Peavine Trail/Road 39 Public Comment Summary

Following the September 24, 2009 Peavine Trail Crossing Alternative presentation at the Prescott Armory, the public was given the opportunity to provide the city with comments regarding the “Peavine Trail Crossing Design Report” and recommendations dated September 23, 2009. The report was distributed at the September 24th meeting and was also available for download on the City of Prescott website. The public comment period was open between September 24 and October 30, 2009. At the request of the city, Lyon Engineering has assembled the comments and prepared this summary recitation to be included as an appendix in the final report. All of the comments have been inserted into this document in their original form, and have been read by both City of Prescott and Lyon Engineering staff. Below is a list of the categories used to help catalog the comments as to their subject nature.

Peavine Trail Crossing Design Alternatives for Granite Dells Estates Proposed Road 39.

Peavine Trestle N of New 89A

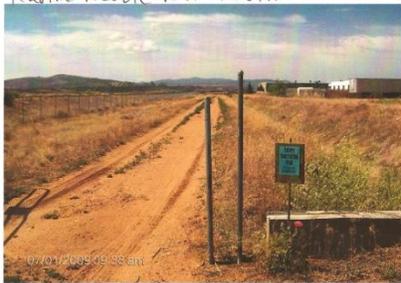
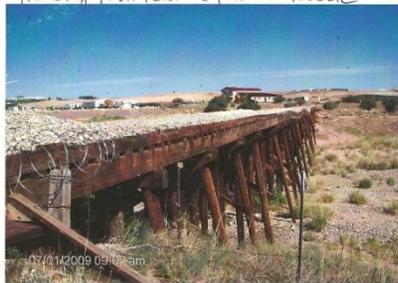
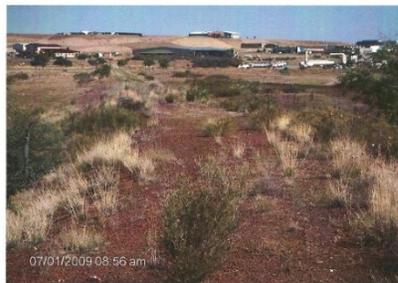
Eric. Do we have measurements for the length of the remaining trestle and then from the trestle north to the Peavine by the horse doctor? We can price out the side rails which should be at least 60" and preferably 6' or higher for the equestrian riders. Tom Devereaux thought the road to Hanson Cement could be lowered and drainage routed toward Granite Creek, so the Steel Truss bridge connector would not need to be raised above the level of the trestle for the industrial traffic below. We can also price out a truss bridge and cement abutments, which should be around \$200K total. There shouldn't be much dirt fill needed since the Peavine and Trestle are already high compared to the road below.

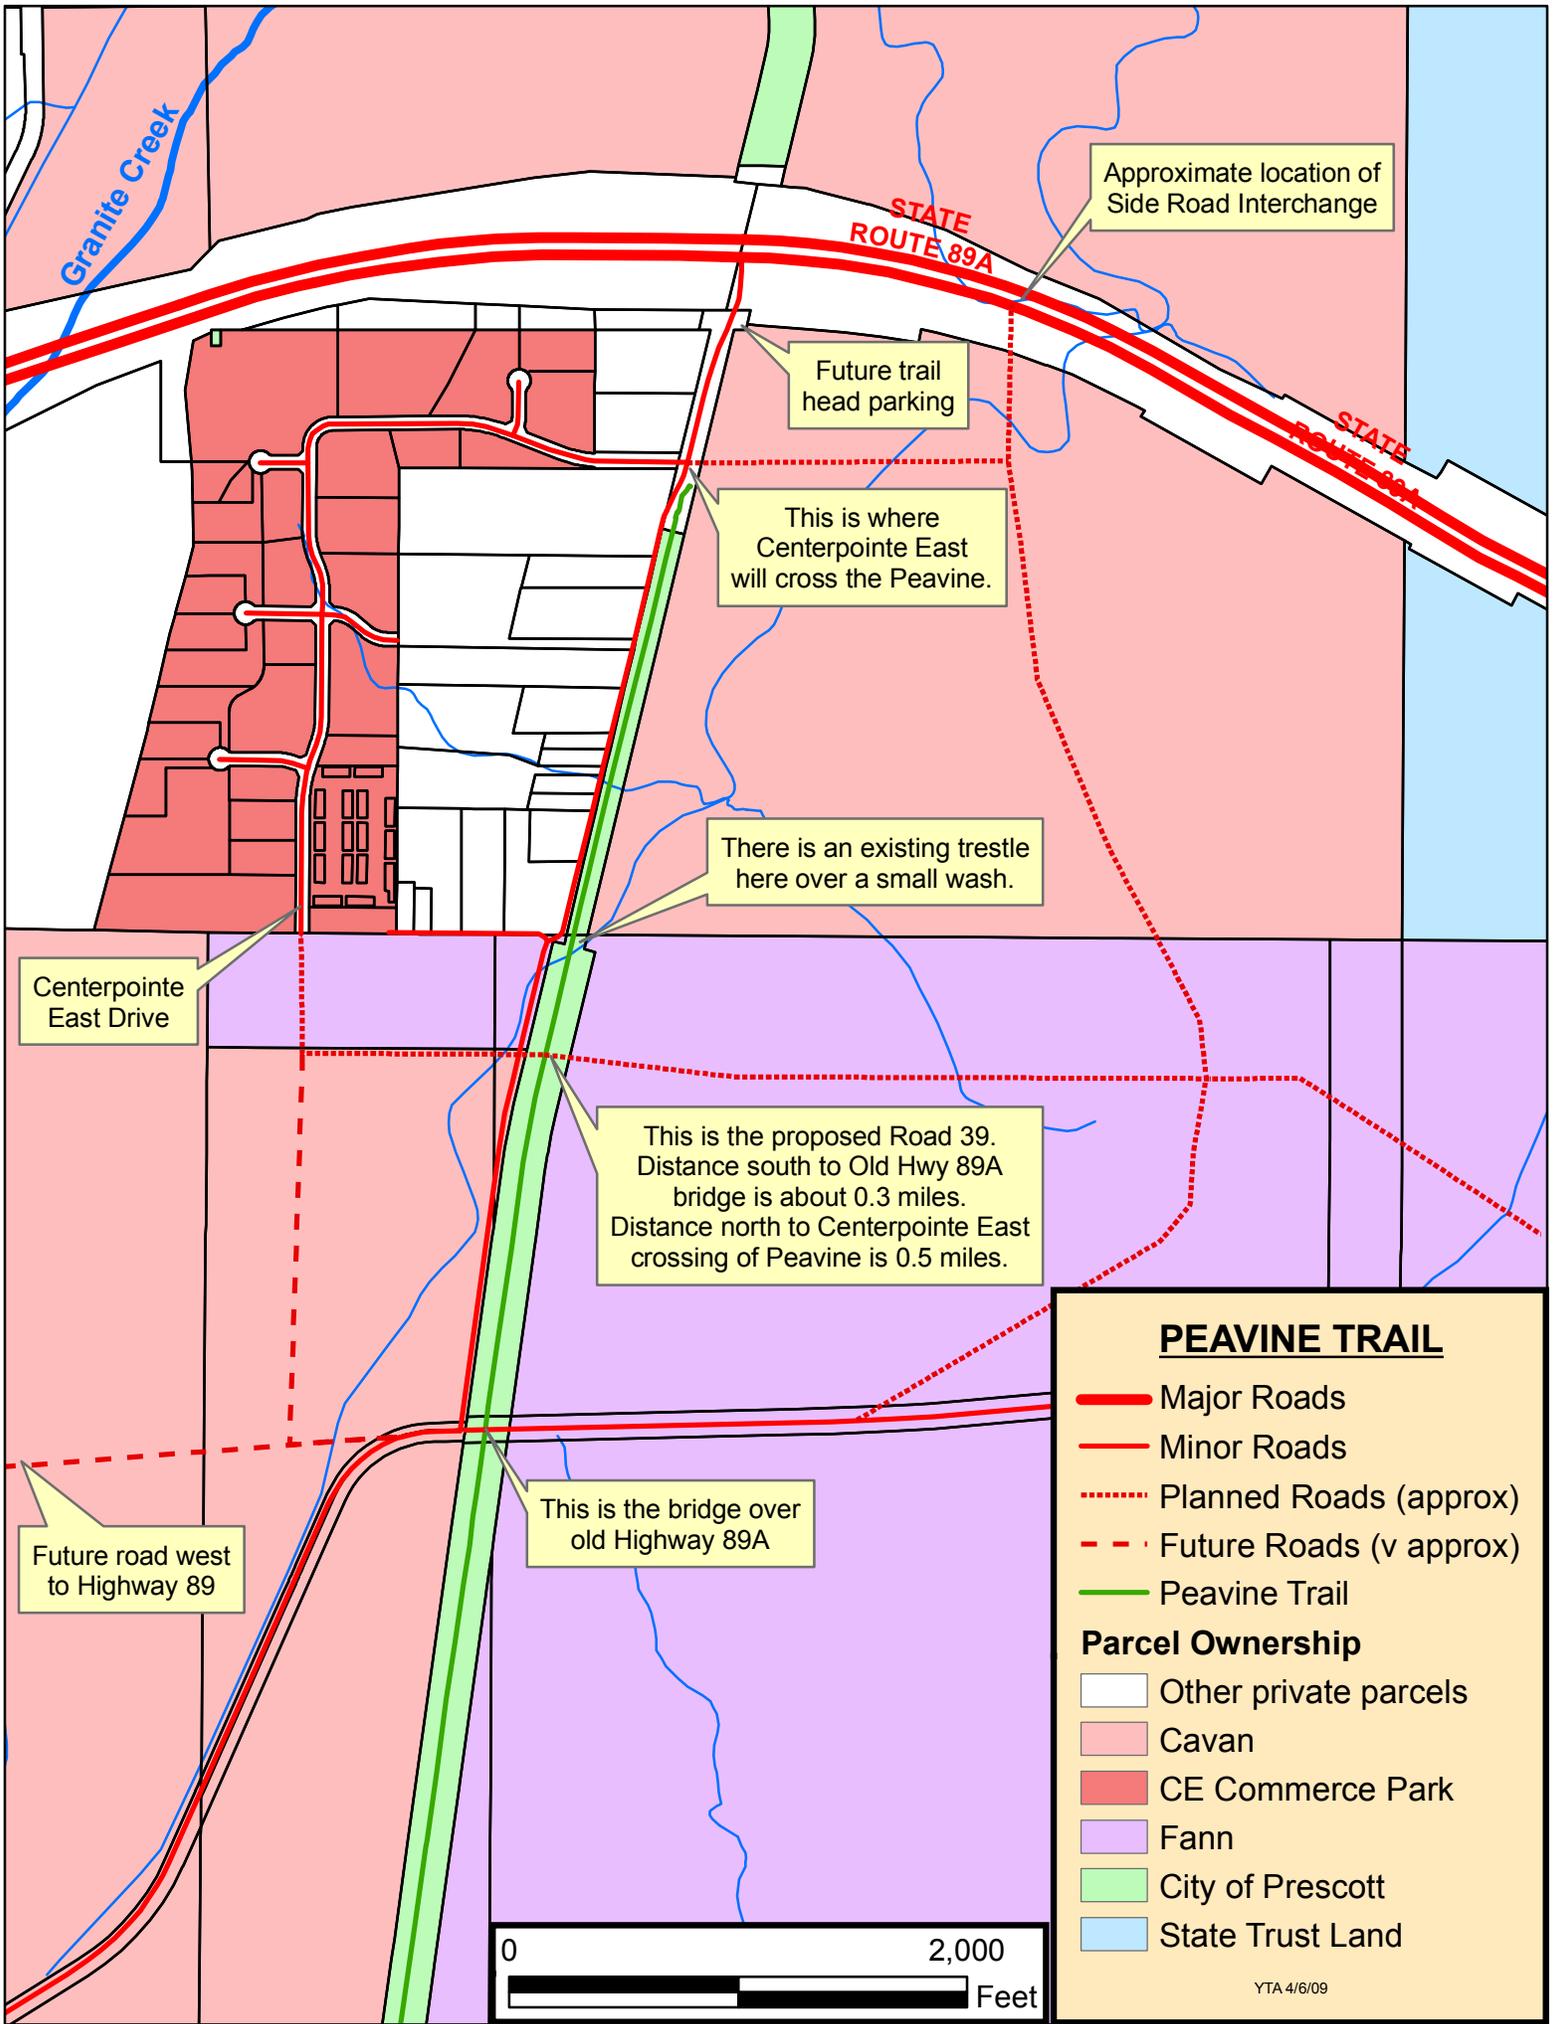
I think I have a solution to Fann's Road 39.

The attached map (the same one I have used before) shows two routes from the Side Road Interchange to where Road 39 crosses the Peavine. The "south" route goes south on the Parkway and then west on Road 39 to the Peavine. The "west" route goes south on the Parkway for a short distance and then west & south on Centerpointe East Drive before turning east on Road 39 to the Peavine. The distance to the Peavine via either route is essentially the same. The reason given to justify the road 39 crossing of the Peavine is because there must be two access routes into/out of an area, in case one route is blocked due to some emergency.

So, the solution is to define the actual crossing by Road 39 of the Peavine as an emergency access route, and have "crash gates" on both sides of the Peavine on Road 39 so there is no every day traffic across the Peavine using the "south" route. These gates are ONLY used in the event of an emergency that closes the "west" route. I think this should meet the "two access route" requirement – please comment. At some future time, if Centerpointe East is extended south to meet the proposed connector road from Highway 89 at the Phippen Museum to the bridge over old Highway 89A, this Road 39 crossing can be permanently closed.

Lyon Engineering

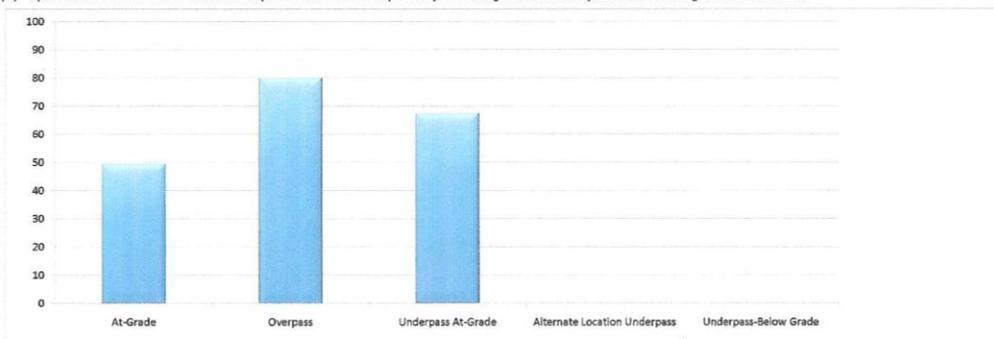
Category Total Weight	Item Weight	At-Grade		Overpass		Underpass At-Grade		Score Range	Comments
			Option 1		Option 2		Option 3			
			Score ¹ (1-10)	Adjusted Weight ²	Score ¹ (1-10)	Adjusted Weight ²	Score ¹ (1-10)	Adjusted Weight ²		
Safety	30									
Trail Users-Peavine		30	3	9	9	27	9	27	1=Least Safe 10=Most Safe	Using a bridge above an intersection with vehicles is far safer Vehicle safety is also increased without pedestrian traffic
Aesthetics	5									
Visual Impact		5	3	1.5	8	4	5	2.5	1=Least Aesthetic 10=Most Aesthetic	Overpass bridge retains historic character of the SF P&P, Railway Overpass bridge sends pedestrians welcome message to users
Usability and Convenience	30									
Pedestrian		10	3	3	8	8	9	9	1=Less Usable 10=Most Usable (Current Condition)	Pedestrians don't need to do anything but enjoy scenery Equestrians do not have to deal with vehicles if trained for bridges Bikes can enjoy a short increase in grade for a safe crossing Maintenance vehicles pay extra attention either way

Equestrian		7	4	2.8	7	4.9	5	3.5		
Bicycle		10	3	3	9	9	9	9		
Maintenance Vehicle		3	6	1.8	6	1.8	6	1.8		
Cost	25									
Structure/Foundation		7	9	6.3	5	3.5	5	3.5	1=High Cost 10=Low Cost	Either alternative will be engineering constructed/certified
Earthwork		4	8	3.2	4	1.6	2	0.8		
Maintenance		4	7	2.8	6	2.4	6	2.4		Bridges mostly maintenance free. At grade high-tech monitoring More visibility when vehicles mix with various pedestrian types Unknown
Energy Usage		2	8	1.6	7	1.4	7	1.4		
ROW Impact		8	10	8	10	8	2	1.5		
Adjacent Property Owner Impact	10									
Encroachment onto Property		5	3	1.5	8	4	3	1.5	1=High Impact 10=Low Impact	Dangerous encroachment on Rails-to-Trails user experience Land owner has access to Granite Dells via Peavine
Usability/Access to Land		5	10	5	9	4.5	7	3.5		
Total	100			49.5		80.1		67.5

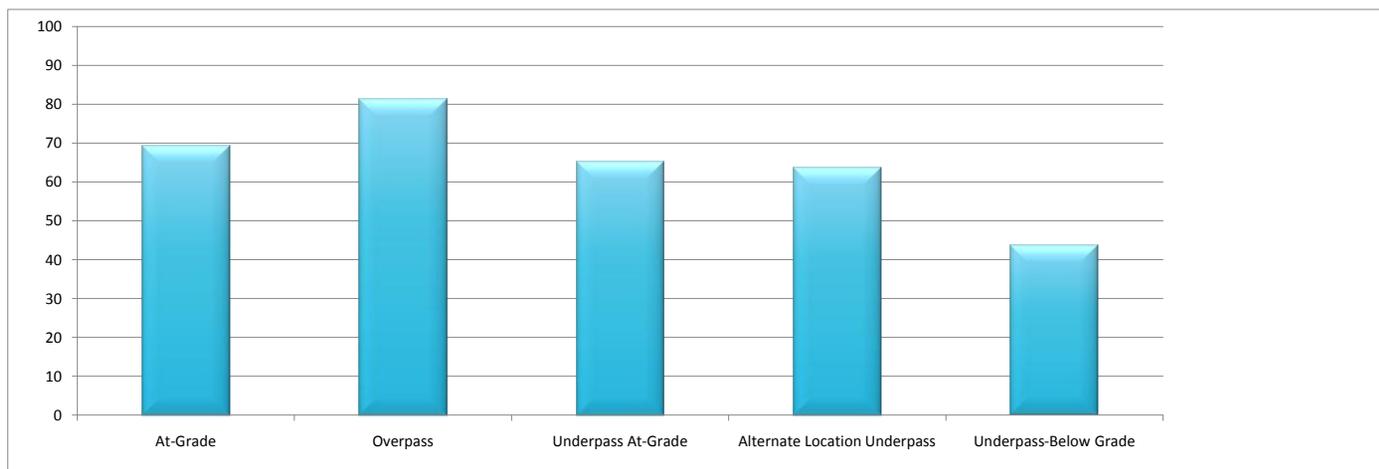
Lyon Engineering presented 5 possible options for the Proposed Road 39 crossing of the Peavine Trail including a decision analysis matrix. Prescott Lakes supports a Grade Separated Peavine Crossing in contrast to that supported by the presented matrix. Attached is our proposed modified matrix which favors option 2, the Grade Separated Overpass. We place a much lower rating on User Safety, Aesthetics, and Useability and Convenience for the At-Grade crossing than the proposed analysis matrix presented. We also provided a higher Category Weight for Aesthetics and lower Category Weight for Adjacent Property Owner Impact. We have not contested the Cost Evaluation nor the Cost Category Total Weight. Our matrix however demonstrates that the other less tangible factors out-weigh the cost differential in favor of a separated grade crossing.

Peavine Trail Crossing Road 39 Comments
Rob Hehlen
Trails Specialist – Prescott National Forest

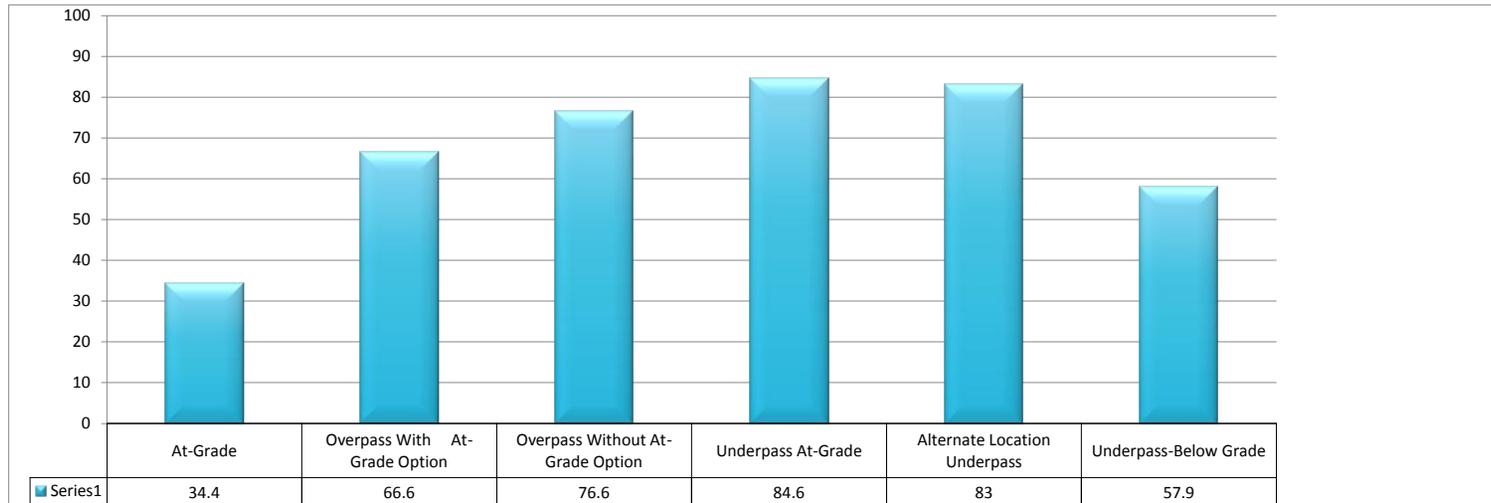
Option 2 – This is actually a combination of a bridge option and option 1 which adds additional cost that isn't required to build the bridge. If this option was asked for by the COP, then I suggest adding an Option 2a that would remove all costs associated with the at grade portion of this estimate. Items that could be removed for and Option 2a:

Property Owner Impact: I think this should be thrown out. The cost estimates compensate the owners for encroachment onto their property, so it wouldn't be 'their' land anymore. Take the 10 points and add it to "Usability and Convenience – Rd 39 Vehicles" (see next paragraph)

One item should be added to the matrix is Usability and Convenience – Rd 39 Vehicles. The reason for this is that Option 1 where vehicles as large as a semi-truck would have to slow down from 35 plus MPH to go over the raised trail crossing (usually to 20 MPH or slower). This would be a major inconvenience to motor vehicle traffic and should be addressed.

Maintenance Vehicle	1	1	10	1	10	1	6	0.6	8	0.8	8	0.8	7	0.7	
Usability and Convenience Road 39 Vehicles	10														1=High Impact
Road 39 Vehicles	10	10	1	1	10	10	10	10	10	10	10	10	10	10	
Cost	25		\$46,225		\$353,215		\$290,077		\$292,759		\$331,330		\$506,664		1=High Cost
Construction/ROW	20	20	10	20	3.1	6.2	4.3	8.6	4.3	8.6	3.5	7	1	2	
Maintenance/Energy Use	5	5	6	3	6	3	10	5	7	3.5	7	3.5	1	0.5	
Total	100		34.4		66.6		76.6		84.6		83		57.9
